MEMORANDUM

TO: PERMIT FILE 67-2365

SUBJECT: FIELD EXAM FOR PERMIT 67-2365

ARCVIEW SHAPE FIELD EXAM 67-2365 BY DAN NELSON

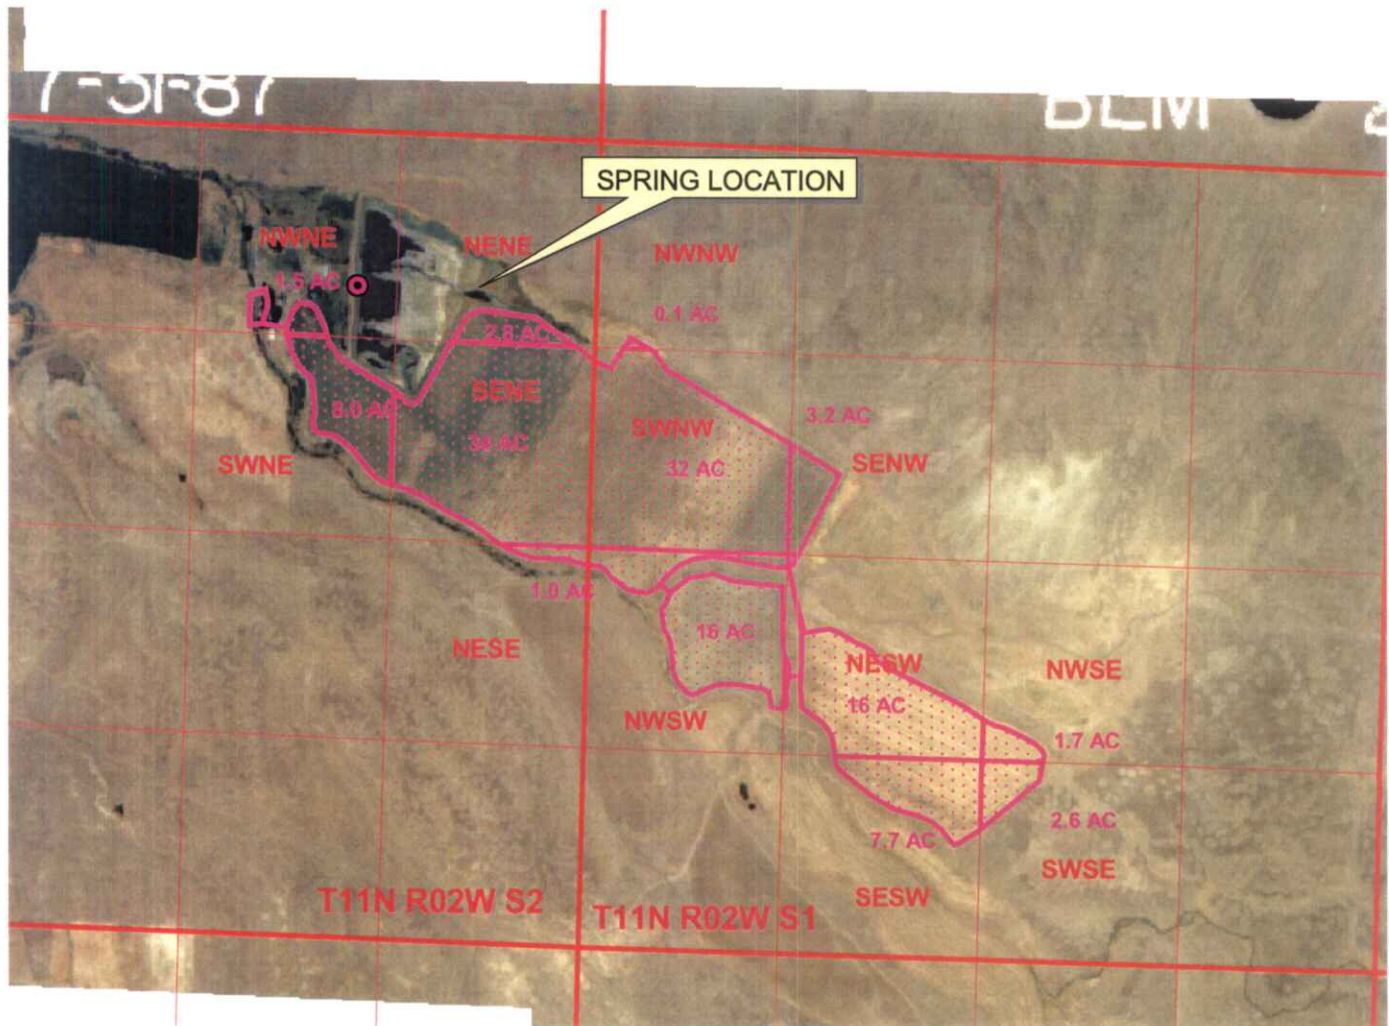
I reviewed this field exam and agreed with the rate of diversion and location of the place of use. However, with new mapping technology and rounding procedures I disagreed with the land being irrigated. This is the third review of this field exam, and everyone disagrees slightly over the lands irrigated. Quentin Nesbitt conducted a field exam in 1988 and found 129 acres and Kelley Christensen re-examined this permit in 1990 and found 120 acres. The ASCS map included with the file showed 125.9 acres when the ½ acre yard was included. When I calculated the acres using ArcView I discovered 126.6 acres. The proof of beneficial use only listed 100 acres and 100 cattle, but the fee was based on the rate of diversion not the number of acres irrigated or livestock, so the acres and cattle numbers shouldn't be limited by the proof of beneficial use form. Whereas the determination of actual irrigated acres was so close, I data entered the acres I found, since this is the shape file that will be entered into the database. Please see enclosed map.

- Section 1:** NESE (1.0 AC), NENE (2.8 AC), NWNW (0.1 AC), SENW (3.2 AC), NWSE (1.7 AC), SWSE (2.6 AC), SESW (7.7 AC).
- Section 2:** NWNE (1.5 AC), SWNE (1.8 AC), SENE (34.4 AC), SWNW (32 AC).

- Section 8:** NWNE (1.5 AC), SWNE (1.8 AC), SENE (34.4 AC), SWNW (32 AC).
- Section 9:** NWNE (1.5 AC), SWNE (1.8 AC), SENE (34.4 AC), SWNW (32 AC).
- Other labels:** 3250 T, 3279 T, 3321 T, 3300, 3400, 3500, 4000, 4500, 5000, 5500, 6000, 6500, 7000, 7500, 8000, 8500, 9000, 9500, 10000, 10500, 11000, 11500, 12000, 12500, 13000, 13500, 14000, 14500, 15000, 15500, 16000, 16500, 17000, 17500, 18000, 18500, 19000, 19500, 20000, 20500, 21000, 21500, 22000, 22500, 23000, 23500, 24000, 24500, 25000, 25500, 26000, 26500, 27000, 27500, 28000, 28500, 29000, 29500, 30000, 30500, 31000, 31500, 32000, 32500, 33000, 33500, 34000, 34500, 35000, 35500, 36000, 36500, 37000, 37500, 38000, 38500, 39000, 39500, 40000, 40500, 41000, 41500, 42000, 42500, 43000, 43500, 44000, 44500, 45000, 45500, 46000, 46500, 47000, 47500, 48000, 48500, 49000, 49500, 50000, 50500, 51000, 51500, 52000, 52500, 53000, 53500, 54000, 54500, 55000, 55500, 56000, 56500, 57000, 57500, 58000, 58500, 59000, 59500, 60000, 60500, 61000, 61500, 62000, 62500, 63000, 63500, 64000, 64500, 65000, 65500, 66000, 66500, 67000, 67500, 68000, 68500, 69000, 69500, 70000, 70500, 71000, 71500, 72000, 72500, 73000, 73500, 74000, 74500, 75000, 75500, 76000, 76500, 77000, 77500, 78000, 78500, 79000, 79500, 80000, 80500, 81000, 81500, 82000, 82500, 83000, 83500, 84000, 84500, 85000, 85500, 86000, 86500, 87000, 87500, 88000, 88500, 89000, 89500, 90000, 90500, 91000, 91500, 92000, 92500, 93000, 93500, 94000, 94500, 95000, 95500, 96000, 96500, 97000, 97500, 98000, 98500, 99000, 99500, 100000.

FIELD EXAM 67-2365

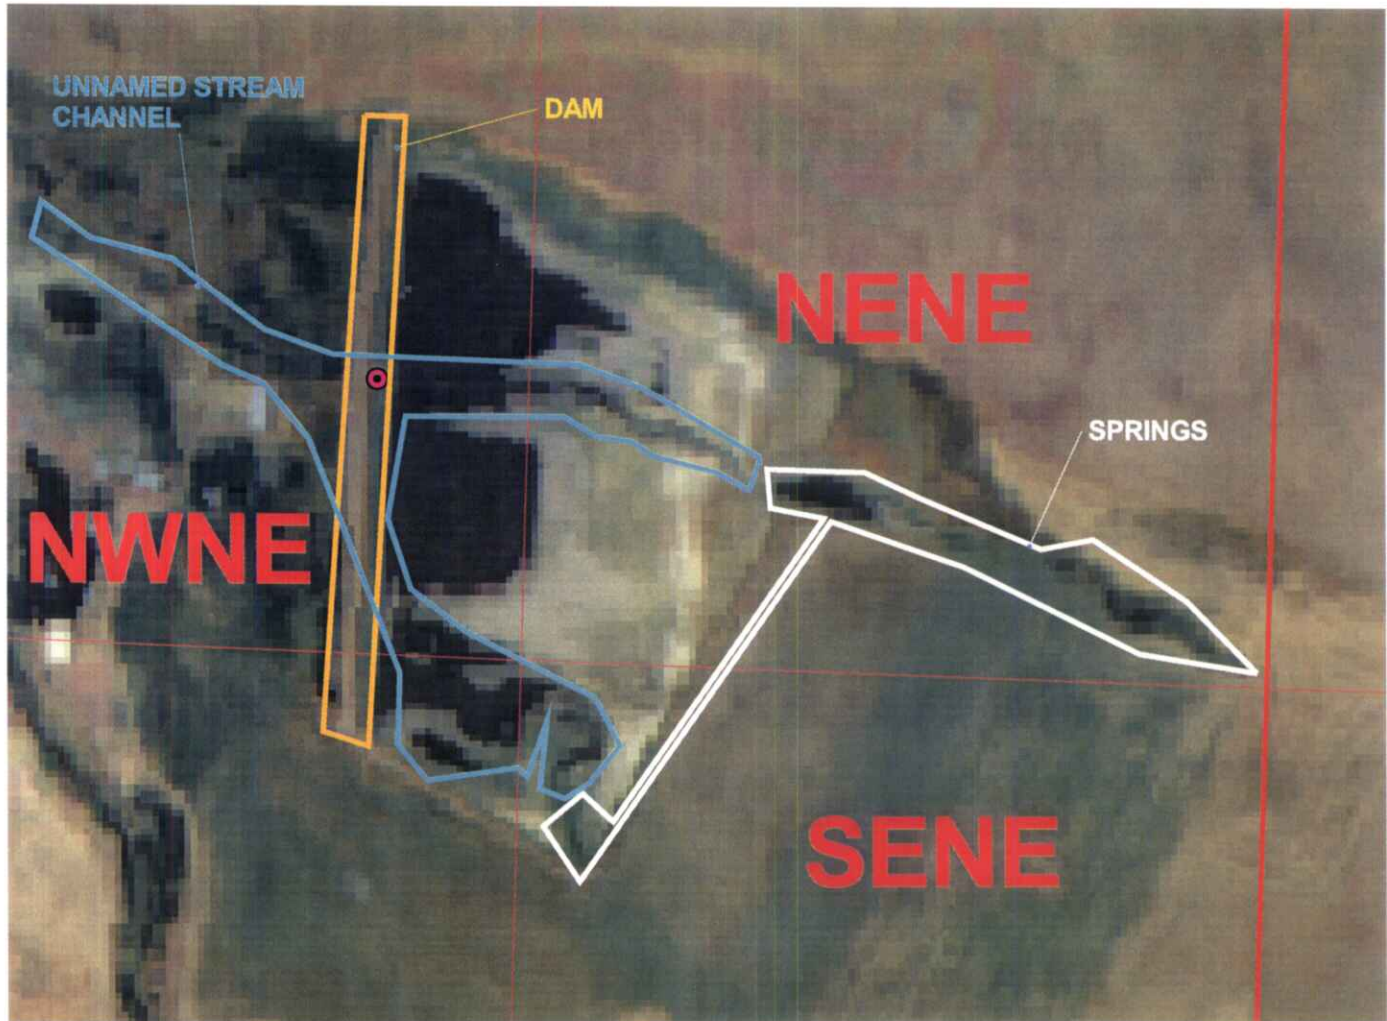
The second issue is whether or not this source is a series of springs or an unnamed stream. Several department personnel have discussed this, and Steve Lester has written a summary on whether the reservoir is on the springs or unnamed stream. After reviewing the maps, it seems to me as though the source for this right should be an unnamed stream. The 1987 aerial map show that the springs are on the east side of the reservoir, and when the reservoir is low, there is a definite stream channel into the reservoir. Therefore, I agree with Steve Lester's comments and have named it an unnamed stream, since the springs were not developed, but a reservoir was developed downstream of the springs in the unnamed stream's channel.

The springs are located on the east side (back end) of the reservoir. The stream channel goes through the reservoir and comes out the other side of the dam. Therefore, the dam has been built on the unnamed stream from the springs and not on the springs themselves.
